HISTORIC AND DESIGN REVIEW COMMISSION

HDRC CASE NO: 2021-463
COMMON NAME: N Palmetto ROW
ZONING: UZROW, H
CITY COUNCIL DIST.: 2
DISTRICT: Dignowity Hill Historic District
APPLICANT: Miranda Garrison/City of San Antonio
OWNER: City of San Antonio
TYPE OF WORK: ROW improvements
APPLICATION RECEIVED: August 31, 2021
60-DAY REVIEW: Not applicable due to City Council Emergency Orders
CASE MANAGER: Rachel Rettaliata

The applicant is requesting a Certificate of Appropriateness for approval to perform pedestrian improvements along N Palmetto between Burnet and Sherman.

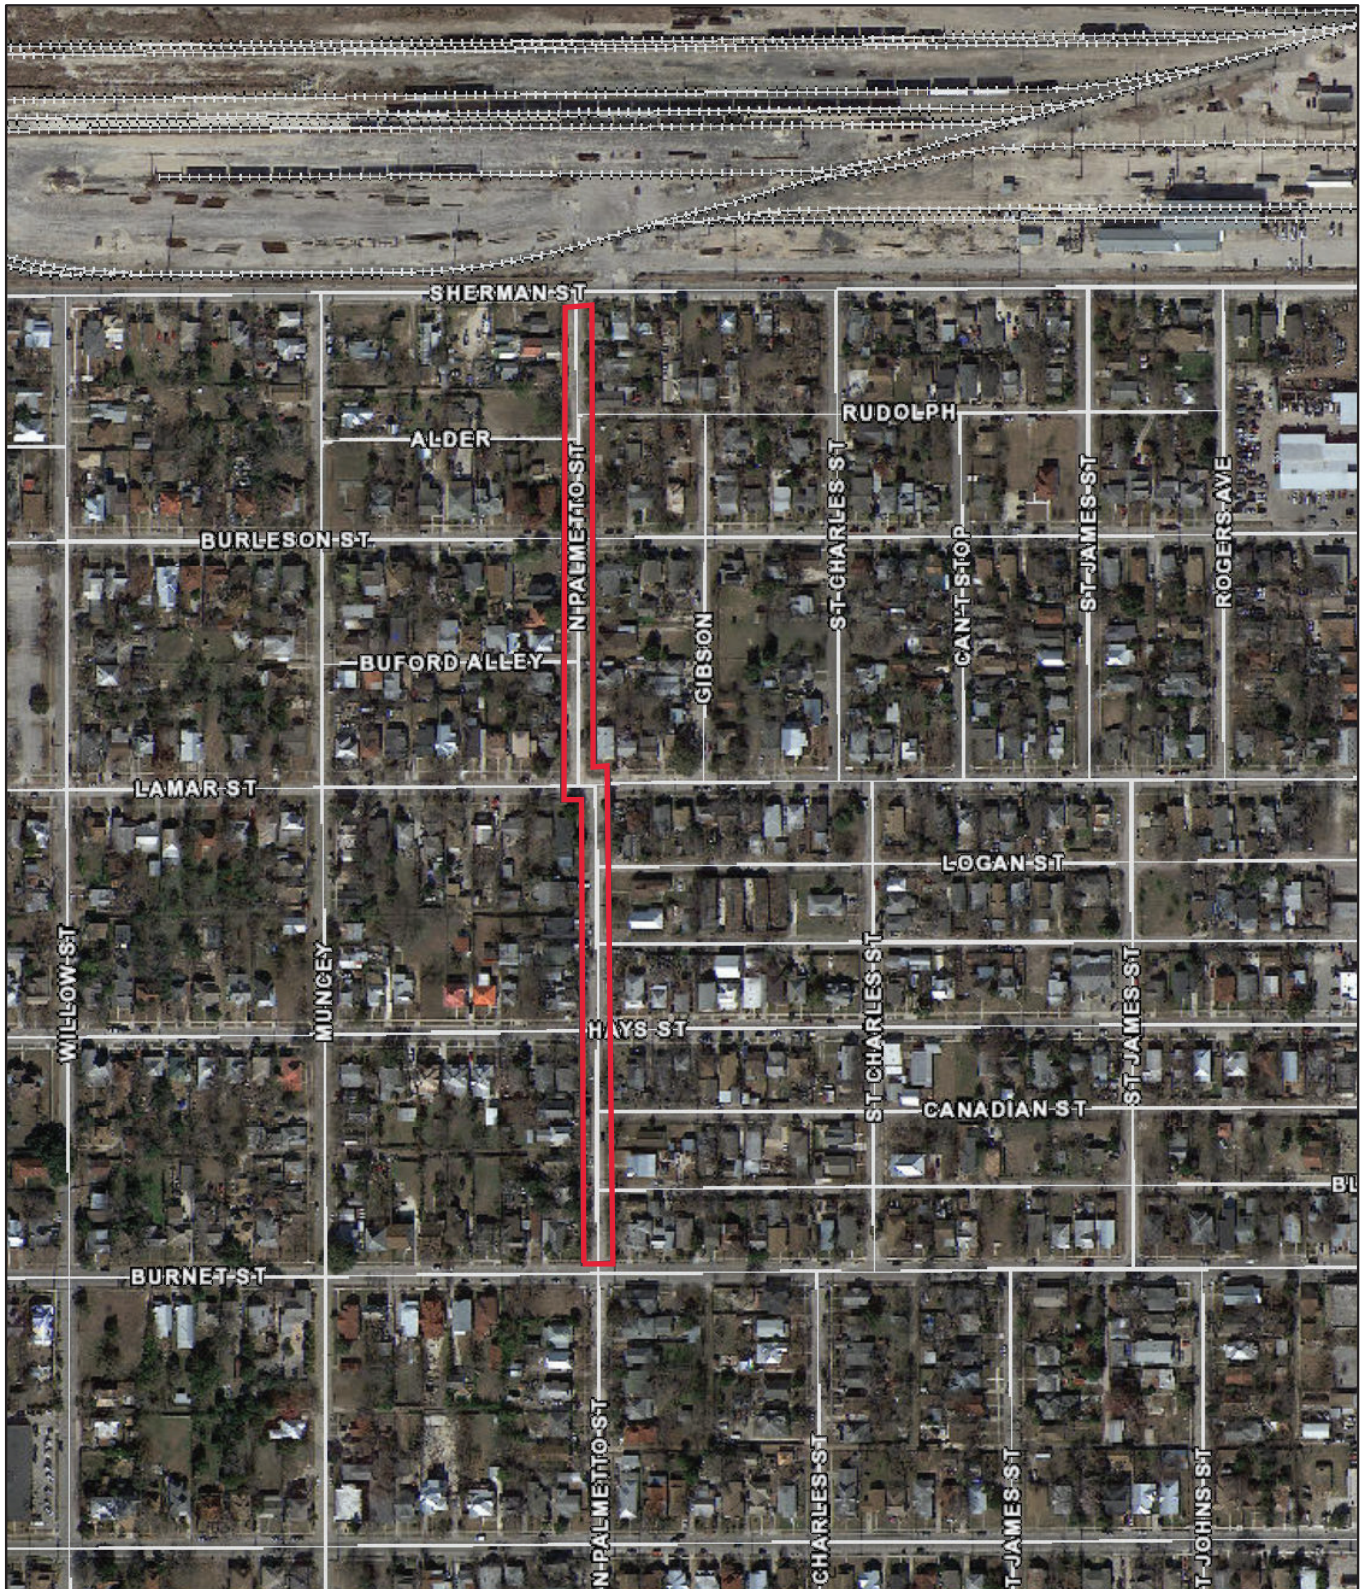
- c. **DRIVEWAY APPROACH INSTALLATION** – The applicant has proposed to install new driveway approaches along the project area. The Historic Design Guidelines for Site Elements state that the width and configuration of original curb cuts should be maintained when replacing historic driveways. The introduction of new curb cuts where not historically found should be avoided. New driveway approaches installed where a historic ribbon driveway exists should tie into the existing ribbon driveway and not feature full-width penetration; the historic

ribbon configuration must be maintained. Any new driveway approaches installed should not exceed 12 feet in width, approaches requested for additional width require additional review. For example, the property at 1017 N Palmetto currently features non-compliant front yard parking. The applicant's site plan shows a wide curb cut proposed for that property. The historic driveway apron should be maintained at this location and not widened to accommodate the existing non-compliant front yard parking. Staff finds that any modifications to existing driveway approach widths or material will require additional review.

- iv. That the historic driveway apron width at 1017 N Palmetto be maintained and not widened to accommodate the existing non-compliant front yard parking.
